Instructions for Handling Attached Correction
and Additions to Supplement No. 1 to
Economic and Environmental Impacts of Alternative
Closed-Cycle Cooling Systems for Indian Point
Unit No. 2

Question III.12

Figure 2. Vegetative Habitat and Areas of Maximum Saline Deposition: Natural Draft, 14 Rainless Days. (Based on Dames & Moore, 1973).

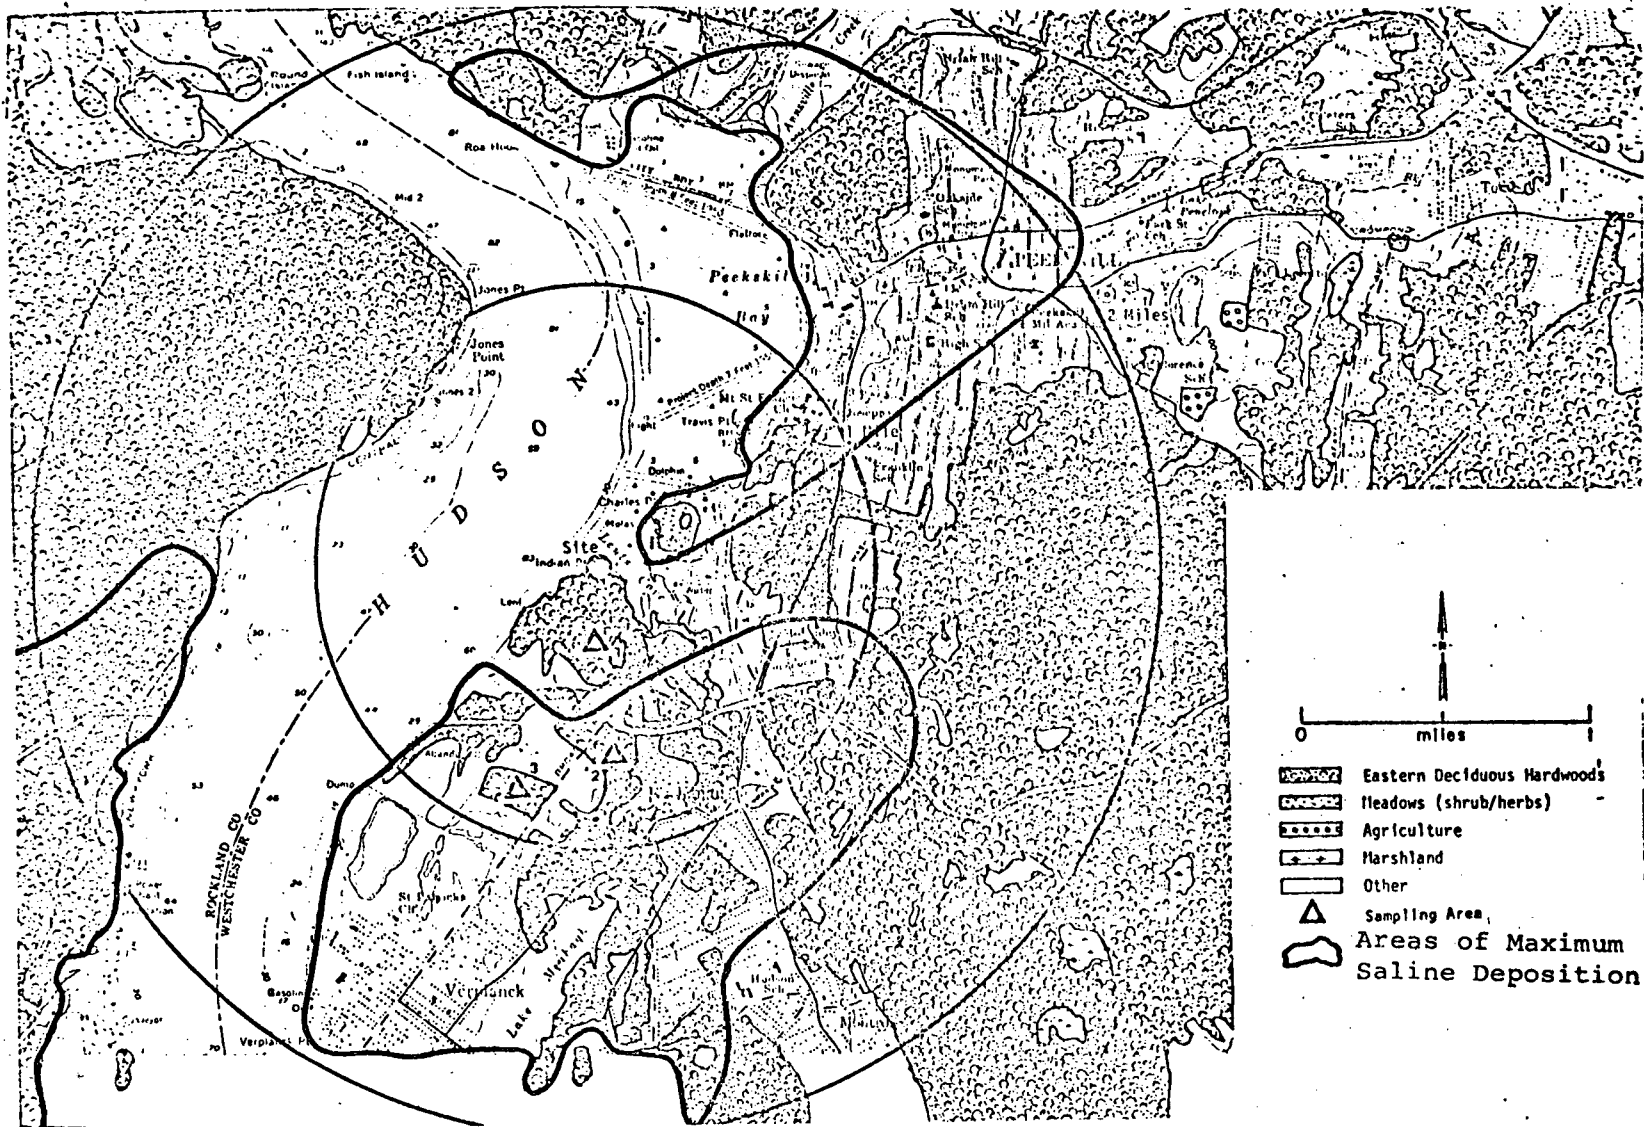
Provide a descriptive analysis of the vegetative habitat at the regions of maximum predicted salt deposition. This information need only be of reconnaissance-level type.

Figures 1 and 2, which are based on the 1973 Dames and Moore report (Appendix D of the Indian Point Unit No. 2 cooling tower report) depict the relationship between vegetative habitats within a two mile radius of Indian Point and the approximate size and location of maximum salt deposition areas. These areas are predicted to be susceptible to injury from salt drift from a mechanical draft or a natural draft cooling tower at Indian Point, assuming 14 consecutive rainless days. The vegetative habitats in the maximum salt deposition areas consist of combinations of 4 basic cover types:

These four basic habitats are closely interspersed throughout the Indian Point area. Any area that is within several kilometers of the Indian Point site and equivalent in size to areas for which maximum saline deposition is predicted, will therefore contain essentially the same basic cover types.

shown in Figures 1 and 2. These major plant species partially comprise an eastern deciduous hardwood habitat generally characterized by several dominant stand types. These dominant stand types are superior to the intermediate and understory stands. Based upon Dames and Moore (1973) and subsequent reconnaissance by Con Edison staff, the dominant overstory species commonly found in the areas of maximum saline deposition are: Oaks, (Quercus rubra, Q. Velutina, Q. alba), shagbark hickory (Carya ovata) and hemlock (Tsuga canadensis). The common understory species are ground canopies of witch-hazel (Hamamelis virginiana), rhododendron (Rhododendron spp.) and flowering dogwood (Cornus florida). Intermediate canopies contain suppressed oaks, hemlock and American hornbeam (Carpinus caroliniana). The common ground covers are Virginia creeper (Parthenocissus quinquefolia), woodfern (Cayptogramma crispera), and a great variety of other assorted woodland plants including Indian pipe (Monotropa uniflora), trillium (Trillium spp.), poison ivy (Rhus radicans), white wood aster (Aster divaricatus) and Solomon-plume (Smilacina racemosa).
